Re: Tru Home 2 Hotel, Bloomington, MN

PRBD201801379 (Building Permit Reference Number)

Please see our responses below to items 12, 17 and 18 from the Bloomington, MN Planning Commission letter dated June 1, 2017.

**A201**

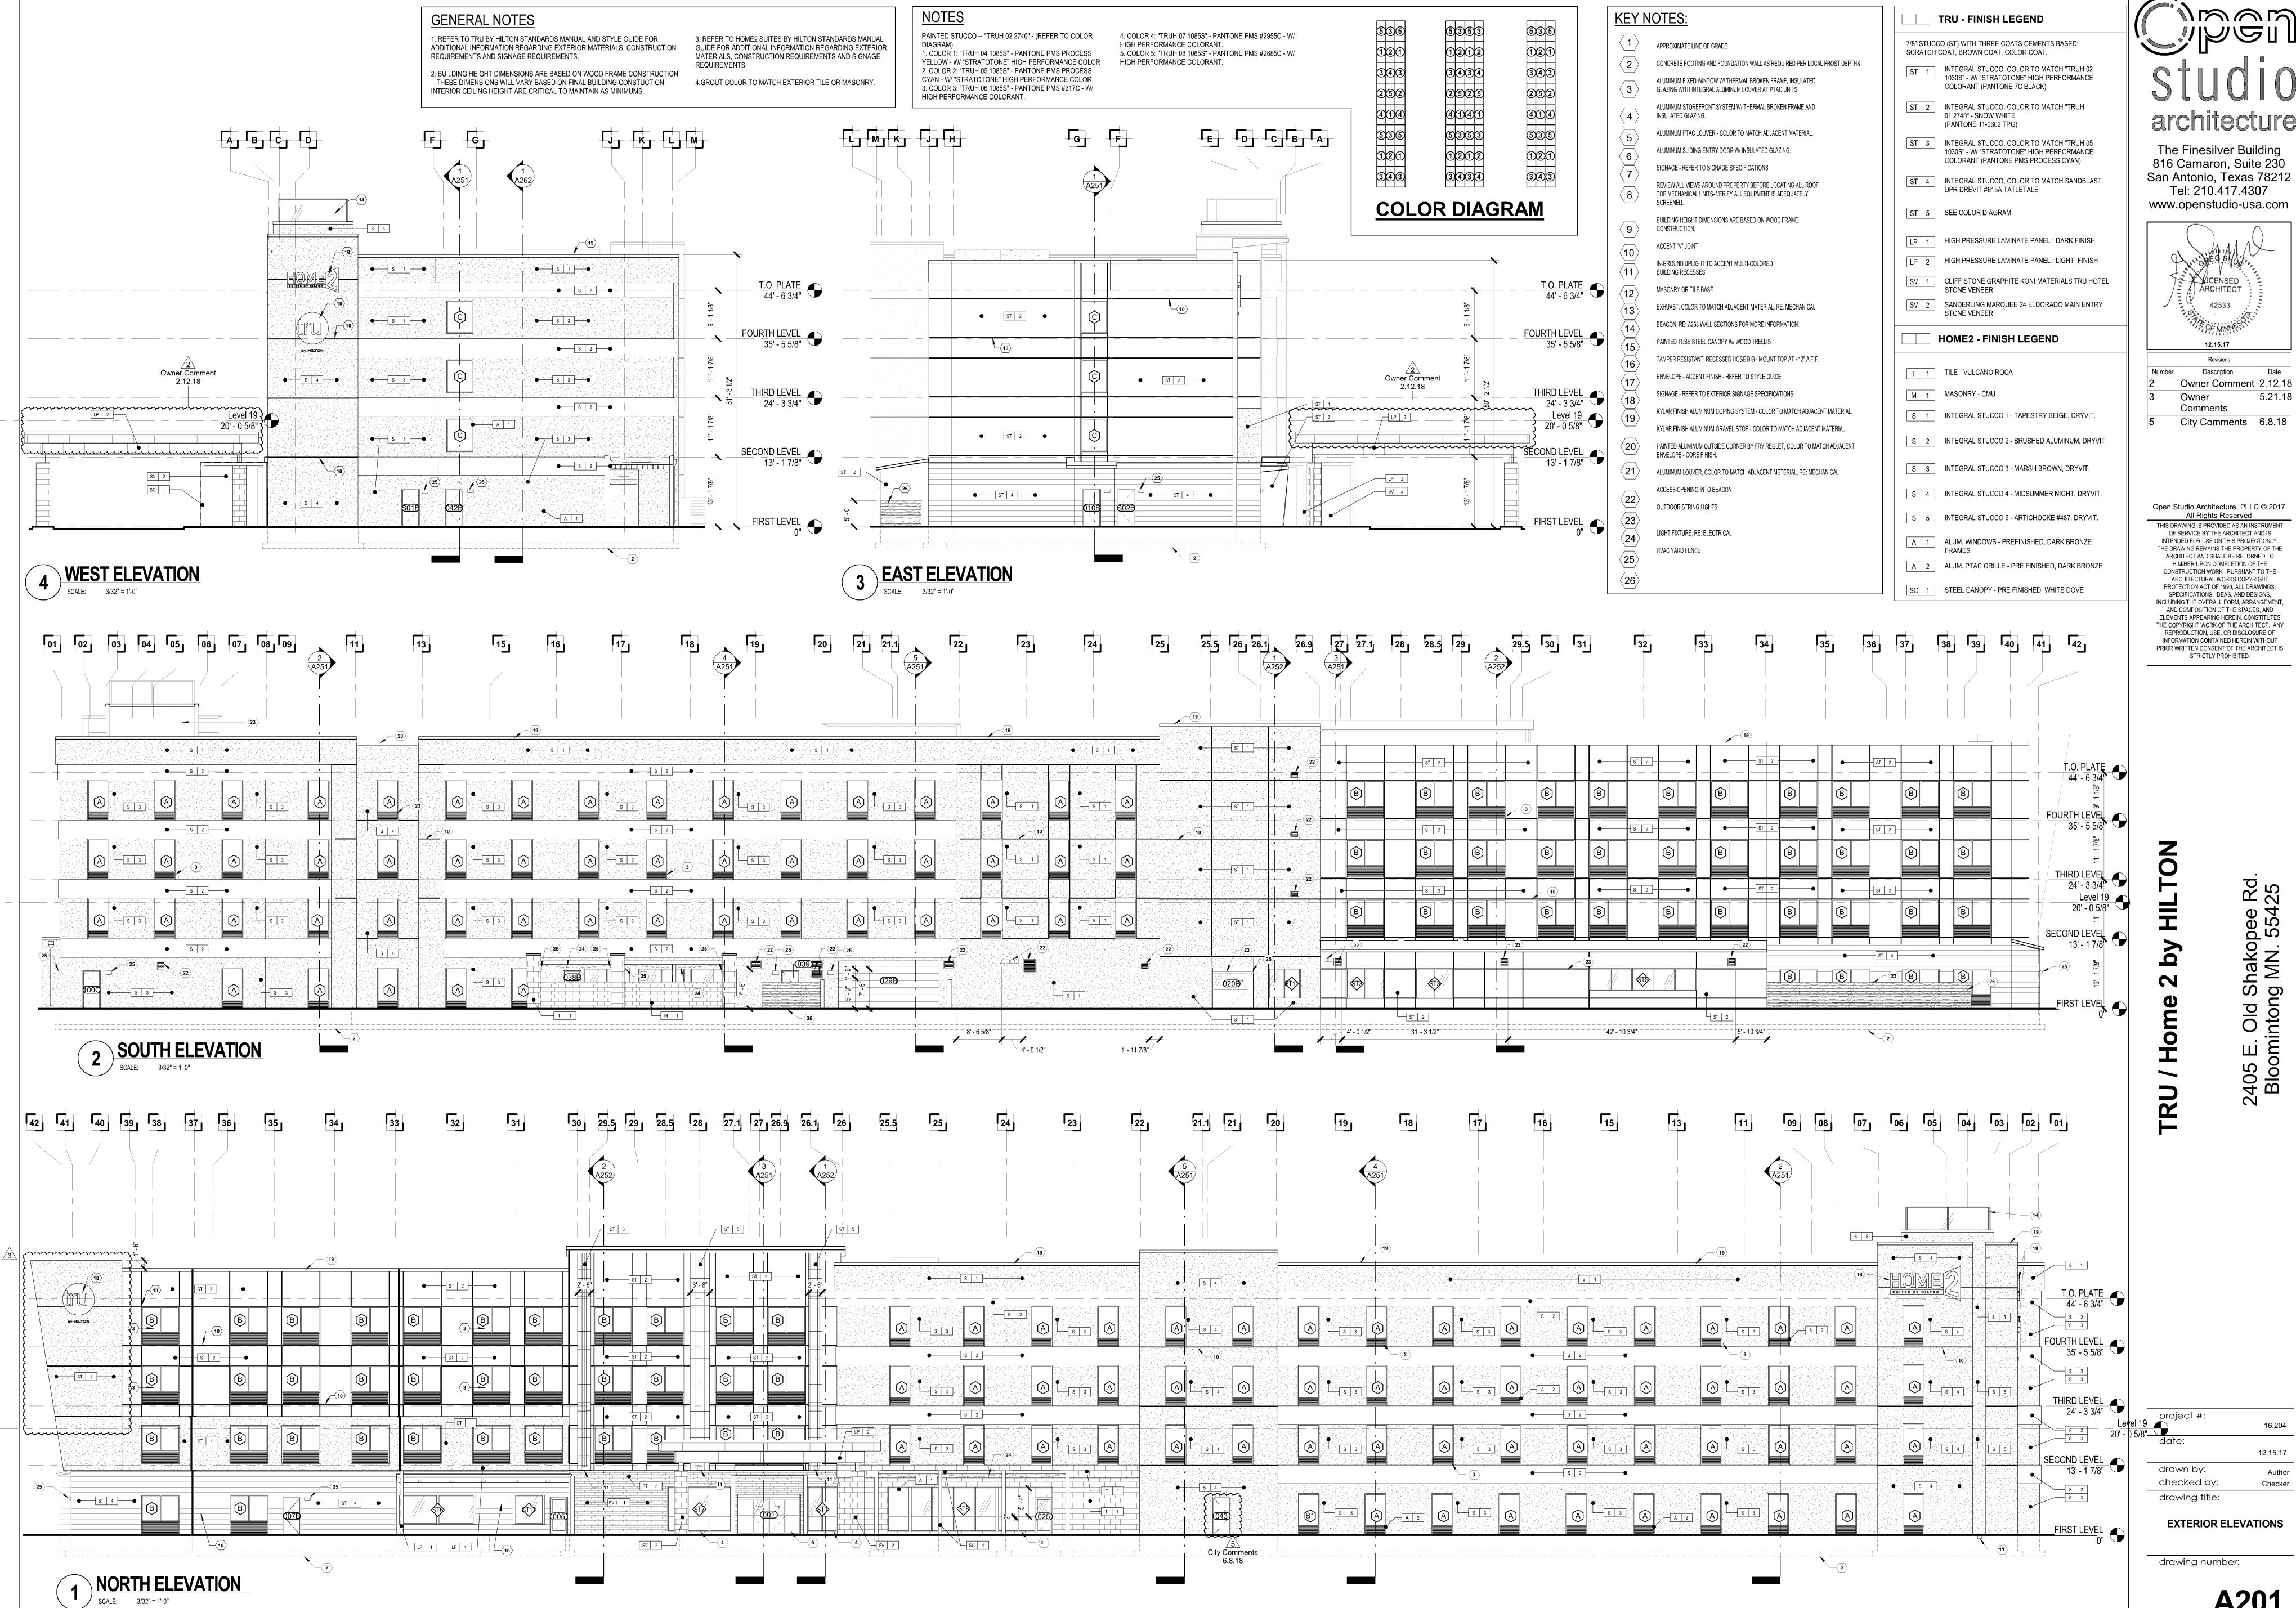
- The crane/s utilized for the construction project referenced above will not meet or exceed 110 feet in height.
- 17. Exterior building materials must be approved by the Planning Manager.

- Please see attachment notating exterior materials. The building has 0% EIFS (all stucco).
  - Acrylic finish will be applied to stucco surface in compliance with Section 19.63.08(h). Product information will be provided to the Bloomington Planning Department prior to installation by the subcontractor once selected.
